Environmental Protection Act 1994

Information request

Our reference: APP0060905; MLA700062; MLA700063

Further information is required to assess an application for a site-specific environmental authority and proposed PRC plan

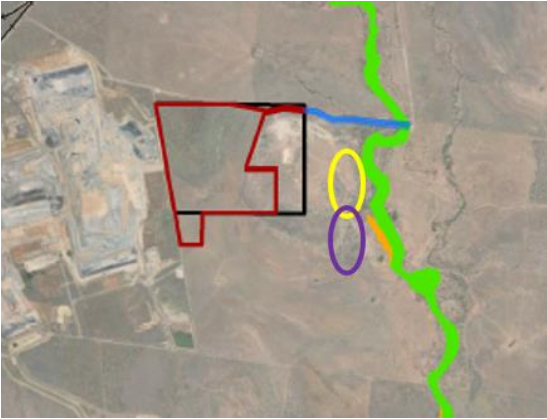
EA Application supporting documentation Section 6 Surface Water Section 6.7	Further clarification is required on the management of the sediment dams in particular Sediment Dam 1 and the management of releases.	- Further clarity/detail to ensure the water is determined to be adequately treated through the proposed methods. - Clarify how the sediment dam's water will be 'treated' if the SD1 is full and it is raining. - Clarify what conditions are required before releases are predicted. - Clarify if releases proposed are only when North Creek is in flow, at a specific flow. - Clarify if there is the ability to stop the release. Include justification for this including how the EVs potentially impacted will be protected. - Identify if there are flow gauges on the release proposed to determine the volume that is released.

- Identify if modelling has been conducted to determine the likely contamination from releases during different events. - Provide additional details regarding the design of 'treatment' dams and how releases will occur including modelling to justify how releases will not cause impacts. - It is stated that SD1 meets requirements however is close to but potentially smaller than the optimum size (pg. 306). Provide details on why the dam has not been designed and assessed for operational/optimum size.
Groundwater		
Section	Comment	Requirement
EA Application supporting documentation Section 7	Site specific groundwater monitoring program: characterising variability It was noted that recent site-specific groundwater monitoring included 8 groundwater bores sampled on 2-3 occasions each, with 5-8 months interspacing each event. All monitoring bores are listed as broadly targeting the "Rangal Coal Measures" (apart for Bore 11 which is missing details of bore characteristics and screening). Establishing baseline data that captures as much natural variability as possible, provides the optimised dataset for establishing site specific triggers and limits for future environmental assessment. Also, the influence of wetter vs. drier years is also important to investigate for this greenfield location. Note. The department recommends ongoing monitoring and highlights the opportunity to monitor ground water quality during the upcoming predicted La Nina for summer/autumn 2020/2021, as well as beyond.	- Review and update bore information with any further data collection as available. - Further characterise groundwater variability including seasonality (as we note that sampling has occurred primarily in winter and spring to date). - Complete ongoing groundwater monitoring (the upcoming predicted La Nina for summer/autumn 2020/2021 may provide excellent opportunity).
